Justification for Class III Permit Modification March 2006 SWMU 138 Operable Unit 1295 Building 6630 Septic System (Technical Area III)

Sandia National Laboratories/NM

**REQUEST FOR SUPPLEMENTAL INFORMATION
RESPONSE AND PROPOSAL FOR
CORRECTIVE ACTION COMPLETE FOR
DRAIN AND SEPTIC SYSTEMS SWMU 138,
BUILDING 6630 SEPTIC SYSTEM AT
TECHNICAL AREA III**

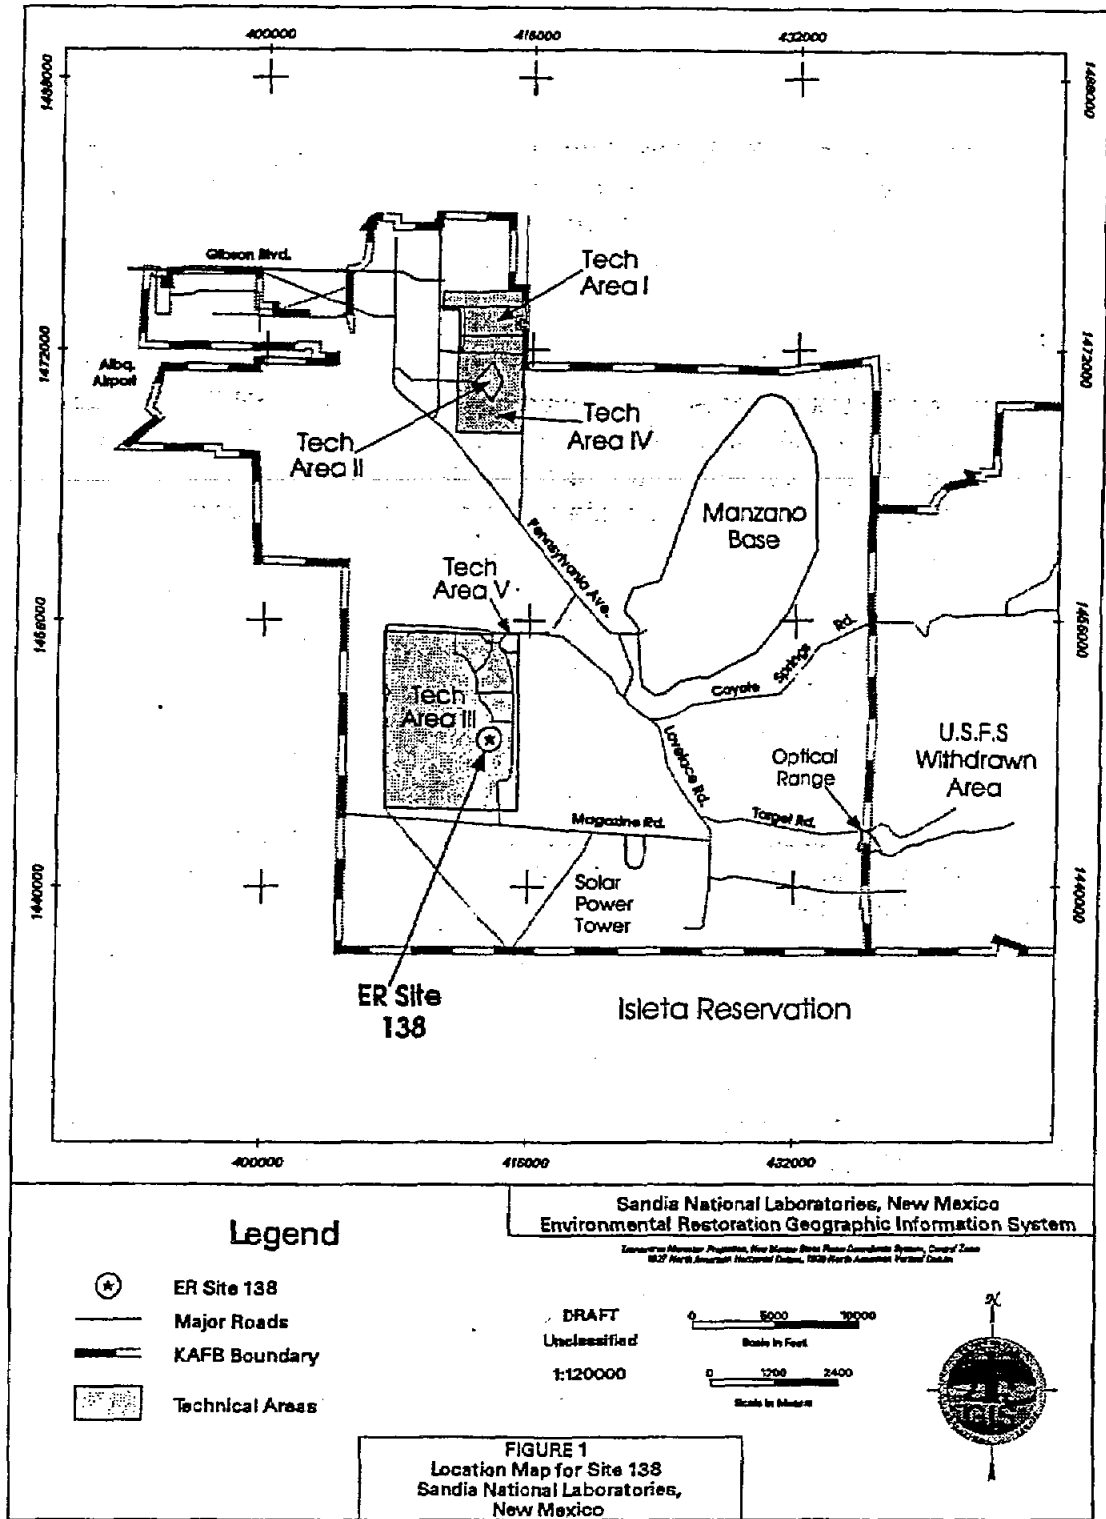
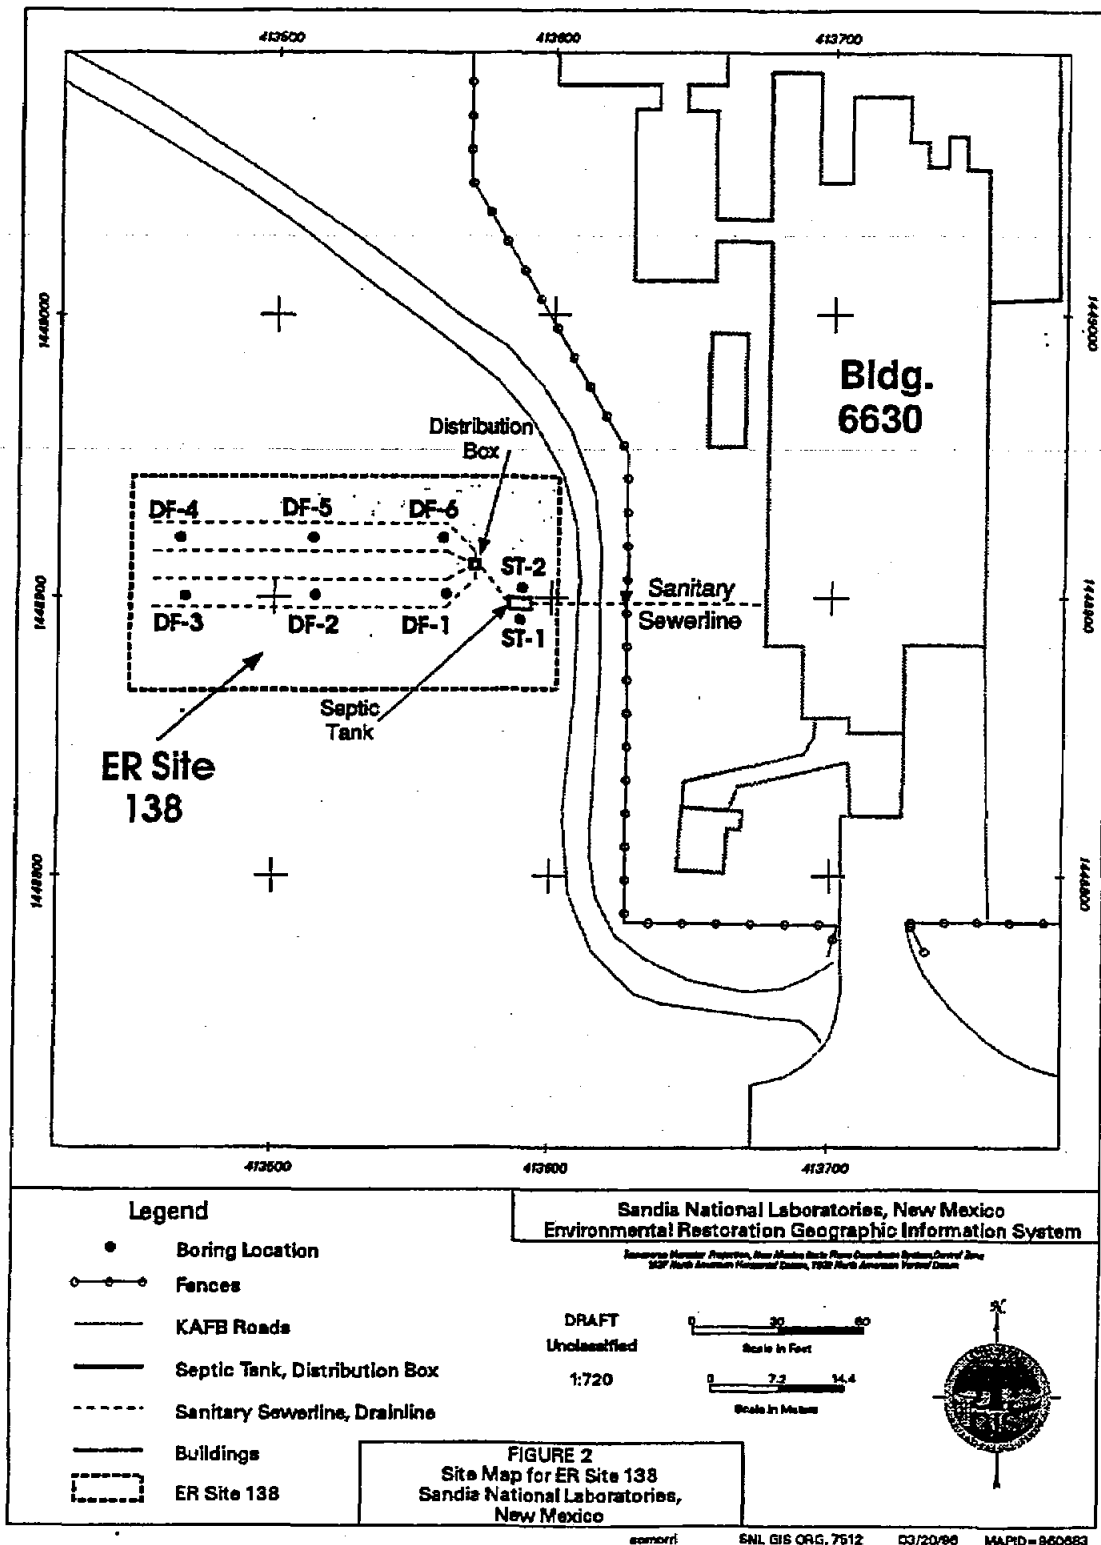
30. **Figures 1-1 and 1-2 - see General Comment 1.**

Response: All submitted maps will be reviewed for completeness with respect to sample locations, wells, drainages, watercourses, PETREX soil-vapor survey (SVS), and any other important features, as applicable. All submitted maps are final, but the word "Draft" had been mistakenly left on the maps for Sites 49, 101, 116, 138, 141, 149, 151, 160, and 161 when they were printed. Replacement maps for these sites are included as attachments under specific comments for Operable Unit (OU) 1295. For all future No Further Action (NFA) proposal submittals, final rather than draft products will be submitted.

Response: See response to General Comment 1.
